From:	Ron Snow
Sent:	Sunday, November 3, 2024 9:16 AM
То:	Vanessa Castro; Alex Zhang
Cc:	Elaine Salinger; Joel Slavit; John Langbein
Subject:	BPAC/DPW Canada Road Your attention needed

BPAC and DPW (Please distribute to all BPAC members)

I want to bring your attention again to the completed Canada Rd project. During the BPAC meeting of October 17, DPW announced the completion of the Canada Rd project. DPW made significant improvements for cyclists. Good to see that occur.

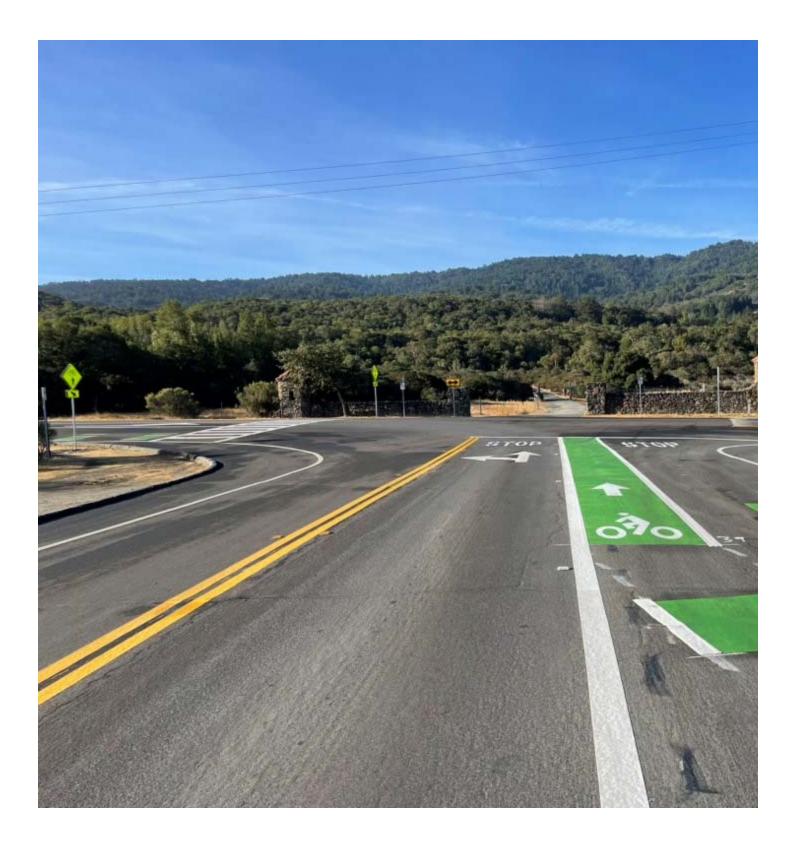
- 3. There seems to be, in my observation, a very dangerous condition for motorists at the intersection of Edgewood & Canada. The cursory view by an Edgewood driver can give a general feeling that all traffic directions stops. Looking at the Canada crosswalk, advance stop lines, and large traffic signs facing away to Canada drivers, it gives an impressing and expectation that all traffic stops. While there is a double arrow sign indicating Canada's cross traffic, it may not be enough to give clear awareness that Canada traffic doesn't stop. This needs to be addressed before this condition materializes into actual accidents. The MUTCD has recommendations (see below).

Here is a drivers view of the intersection and I hope you visit the intersection to make your own assessment. At first impression, many drivers may think the cross traffic stops. There are lots of visual clues to support this perception: There is a stop limit line at the intersection for SB Canada traffic, NB Canada traffic has a high visibility crosswalk and signage that, for the Edgewood driver's first glance might register as a stop signs facing Canada traffic (not stop signs). Even the massive entrance towers and walls on the east side help define the geometry and add to the impression.

MUTCD has this sign that would improve driver's awareness, especially if it was close to the associated stop sign. It could be across the intersection to improve the existing double arrow sign, but may be not as effective as next to or on the Stop sign.

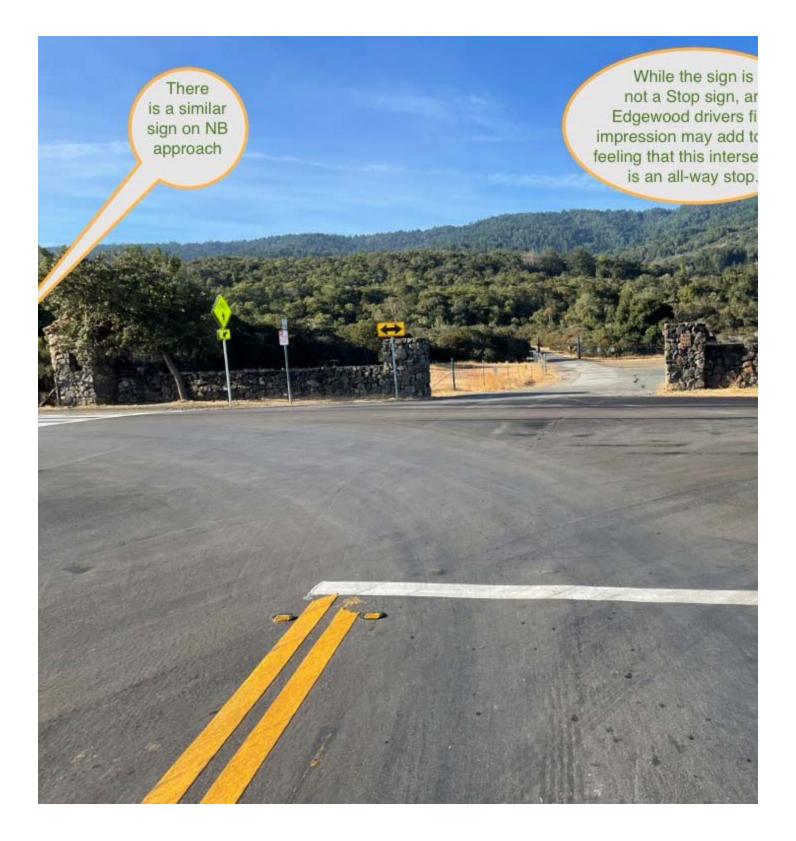
- 4. Dangerous NB Canada Rd. drainage culvert was not addressed. It is just north of Edgewood road at the locations of the recent cyclist's death. The culvert may have contributed to that deadly accident. The drainage culvert still reduces the bike lane by half, often with cyclists having to enter the traffic lane to avoid it and the dangerous edge it forms. It seems that a solution could (and should) be put in place to reduce the danger and widen the bike lane to full width.

Here is a photo of the drain culvert where the deadly cyclist accident occurred. It reduces the bike lane by about half. Could/should this unsafe situation be addressed? During my observations, cyclists enter the travel lane to avoid the danger.
